MRP-227, Revision 1 Requests for Additional Information

NRC Public Meeting, Rockville, MD

February 15, 2018

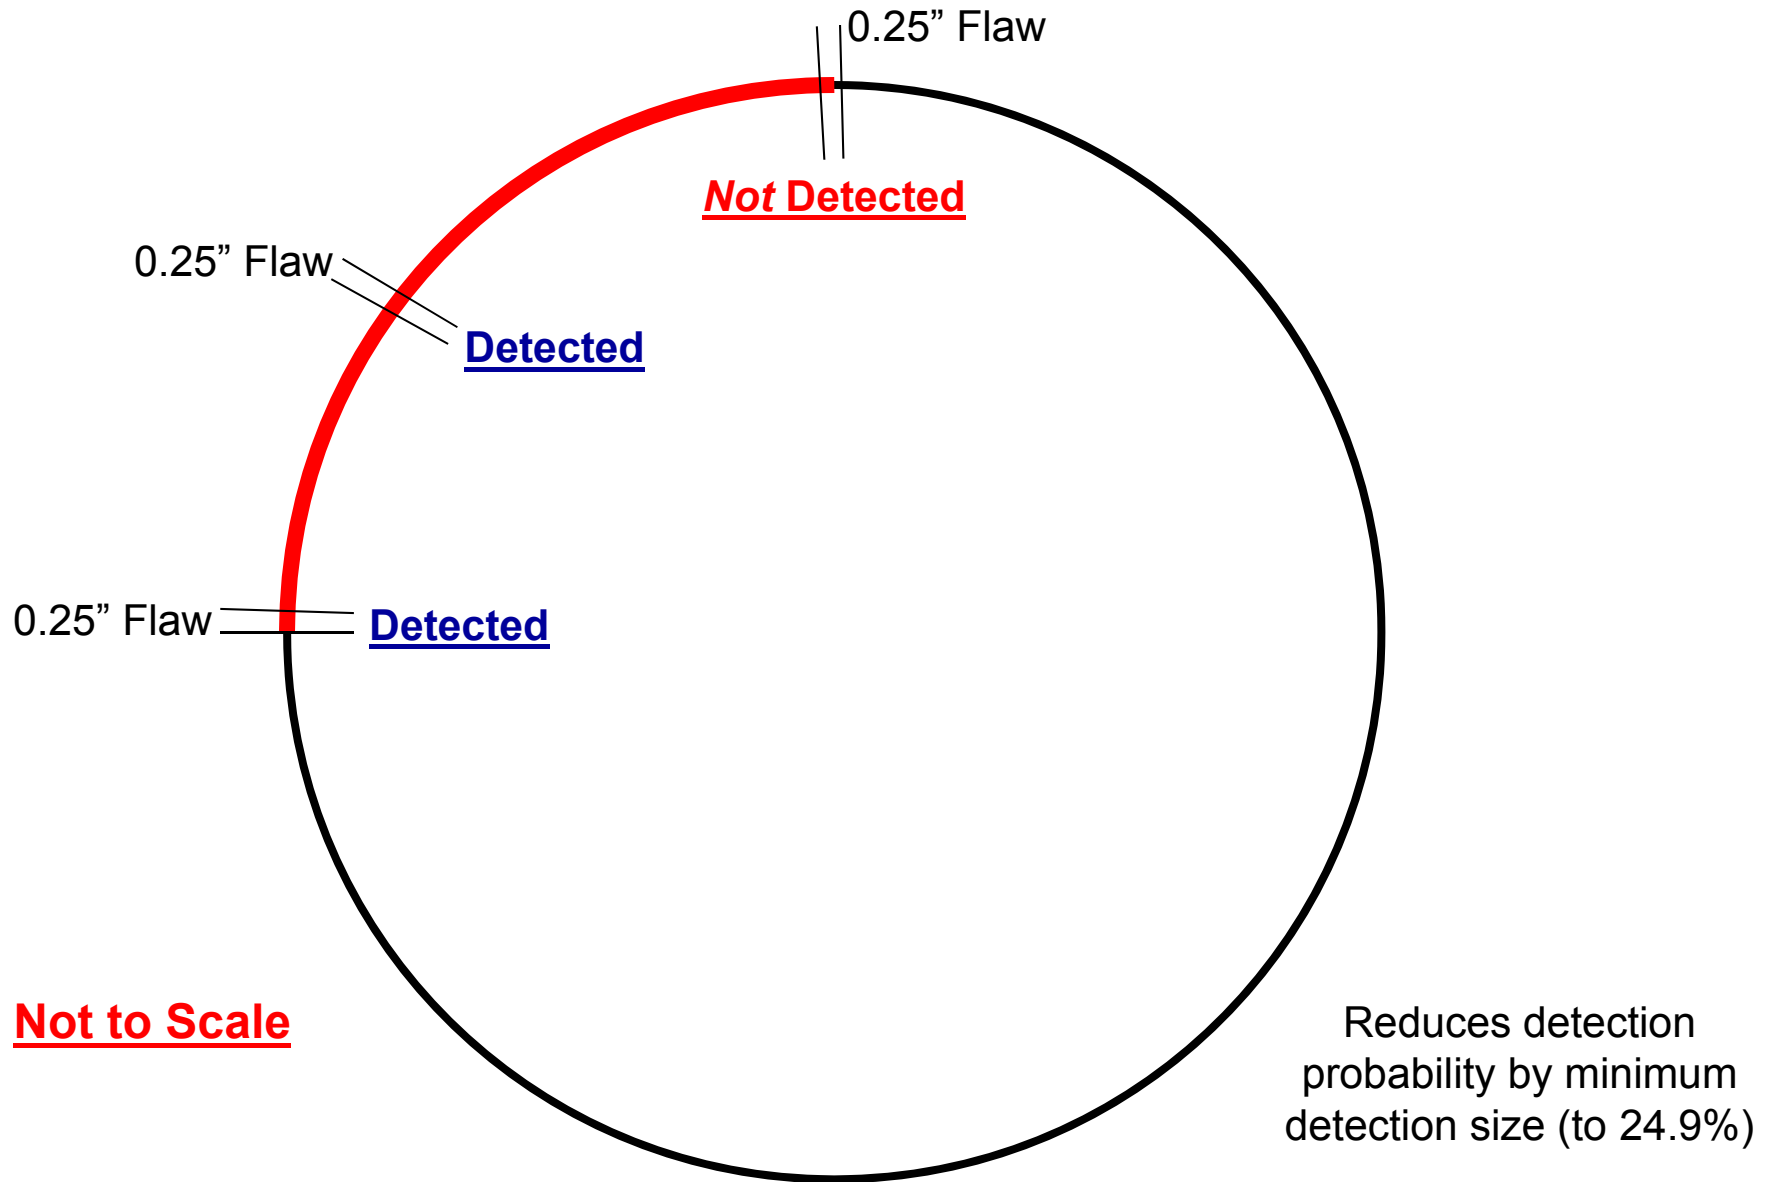
- RAI 5, Tables 1-3, what is the probability of detection for each crack size? How do you get $>25\%$ probability when inspecting a 25% sample with only one crack present? (Maybe provide an example of one of these calculations).

- “Probability of Detection” (POD) refers to two things:
 - Probability that a particular EVT-1 inspection will detect a crack of a certain size
 - Probability of detecting one or more cracks of a specific size in a typical core barrel weld length
- Inspection POD
 - Implicitly included in the response to RAI 5 in minimum detectable crack size assumptions (0.25” in the response) and treatment
 - Cracks below 0.25” assumed to have POD of zero (conservative)
 - Cracks 0.25” and longer assumed to have POD of 100%
 - Expected to be close to the real probability of detection for longer cracks
 - MRP-228 inspection standard EVT-1 requirements maximize POD
 - Demonstration, cleanliness, travel speed, angle, distance, and lighting requirements.
 - POD vendor and inspection system specific, thus not included in calculations
